SUBJECT: BEAVER VALLEY POWER STATION, UNIT NO. 1 - RELIEF REQUEST NOS. PRR1, PRR2, PRR3, PRR4, PRR5, PRR6, PRR7, PRR8, PRR9, PRR10, PRR11, PRR12, PRR 13, AND VRR1 REGARDING THE FOURTH 10-YEAR INSERVICE TESTING PROGRAM RELIEF REQUESTS (TAC NOS. MD5118 - MD5131)

SAFETY EVALUATION BY THE OFFICE OF NUCLEAR REACTOR REGULATION
REGARDING THE FOURTH 10-YEAR INTERVAL INSERVICE TESTING PROGRAM FOR
RELIEF REQUEST NOS. PRR1, PRR2, PRR3, PRR4, PRR5, PRR6, PRR7,
PRR8, PRR9, PRR10, PRR11, PRR12, PRR13, AND VRR1
FIRSTENERGY NUCLEAR OPERATING COMPANY
FIRSTENERGY NUCLEAR GENERATION CORP.
BEAVER VALLEY POWER STATION, UNIT NO. 1
DOCKET NO. 50-334

Figure PRR11-7

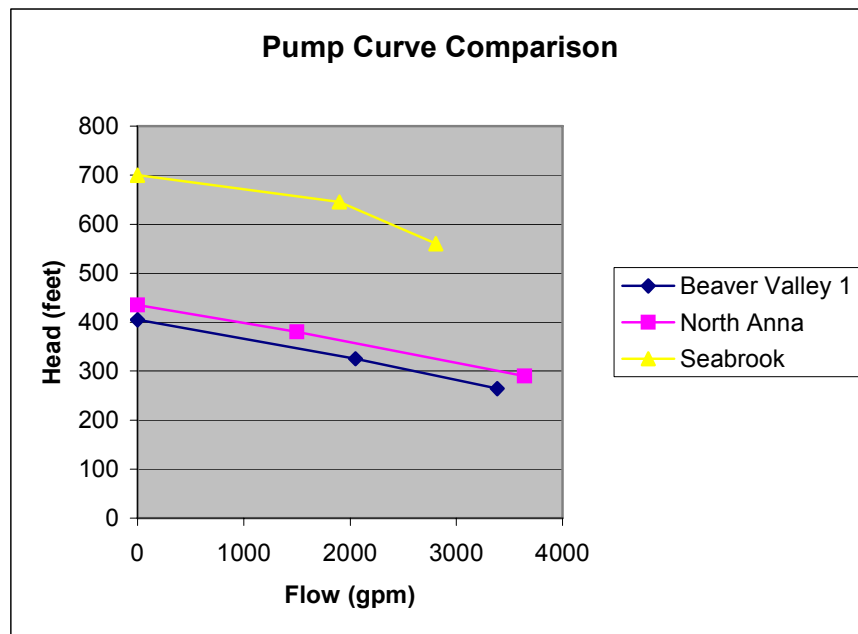
Similar relief requests were granted for the North Anna Station recirculation spray pumps (Reference 3.9.6.1) and the Seabrook Station containment spray pumps (Reference 3.9.6.2). The typical pump shutoff, test and design/accident head-flow data for North Anna Station, Seabrook Station and BVPS-1 are summarized in the table on Figure PRR11-7. Based on these head-flow data, the typical pump head-flow curves for the three plants were plotted for

comparison purposes. As can be seen from the figure, the curves for the three plants have similar shape and are well sloped (The developed head at the test flow rate for BVPS-1 is 20% below the pump shut off head). Therefore, testing at the reference flows for BVPS-1 will detect pump degradation because pump curve is well sloped at the point of testing.

Figure PRR12-1: Quench Spray Pumps Test Circuit

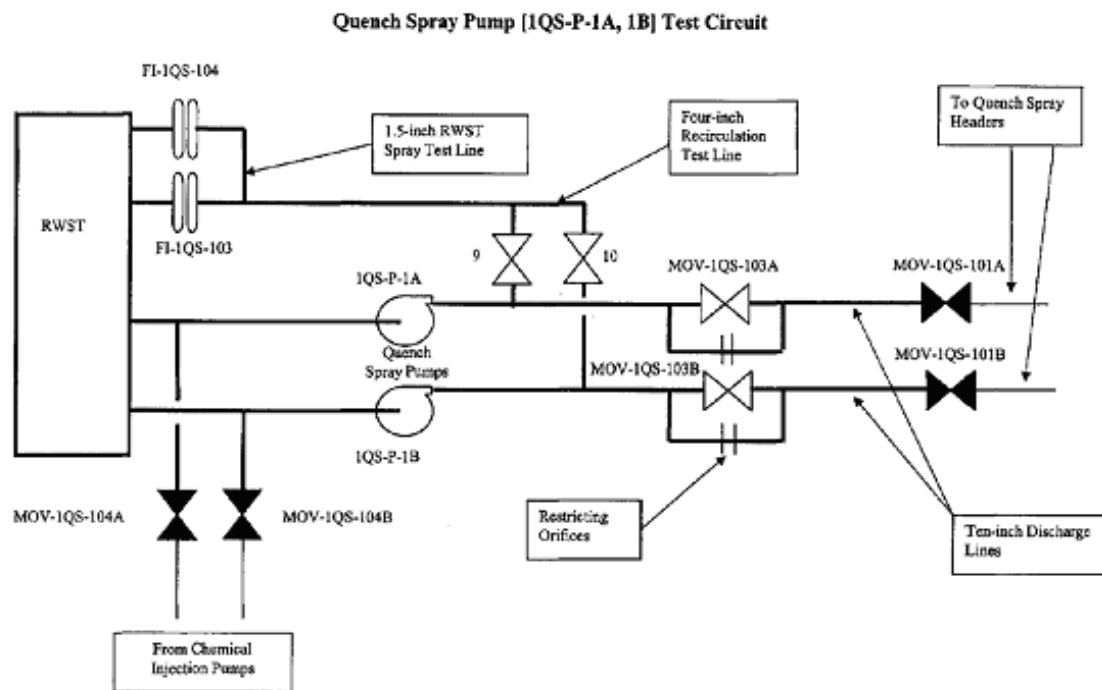
The test circuits identified in [Figure PRR12-1] will be used to satisfy testing requirements.

Figure PRR12-4

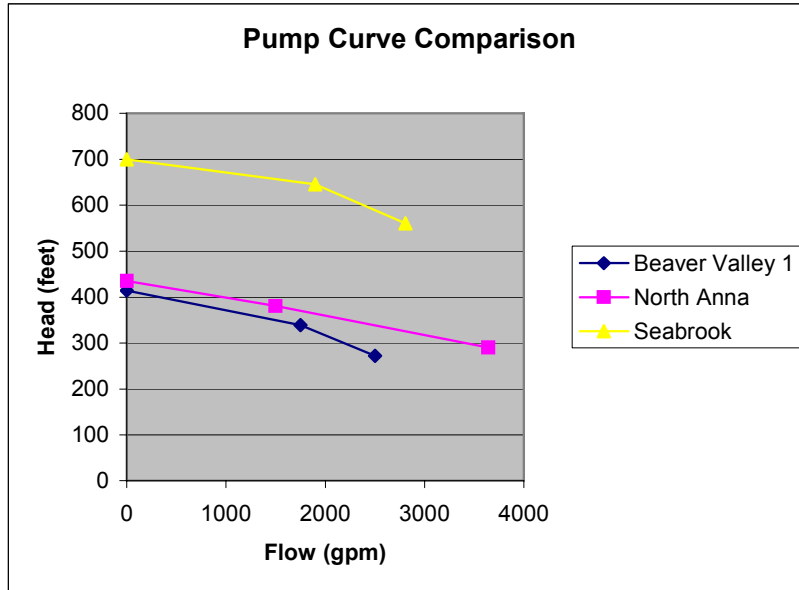
Similar relief requests were granted for the North Anna Station recirculation spray pumps (Reference 3.10.6.1) and the Seabrook Station containment spray pumps (Reference 3.10.6.2). The typical pump shutoff, test and design/accident head-flow data for North Anna Station, Seabrook Station, and BVPS-1 are summarized in the table on Figure PRR12-4. Based on these head-flow data, the typical pump head-flow curves for the three plants were plotted for comparison purpose. As seen from the figure, the curves for the three plants have similar shape and are well sloped (The TDH at the test flow rate for BVPS-1 is 18% lower than the pump shut off head). Therefore, testing at the reference flows for BVPS-1 will detect pump degradation because the pump curve is well sloped at the point of testing.
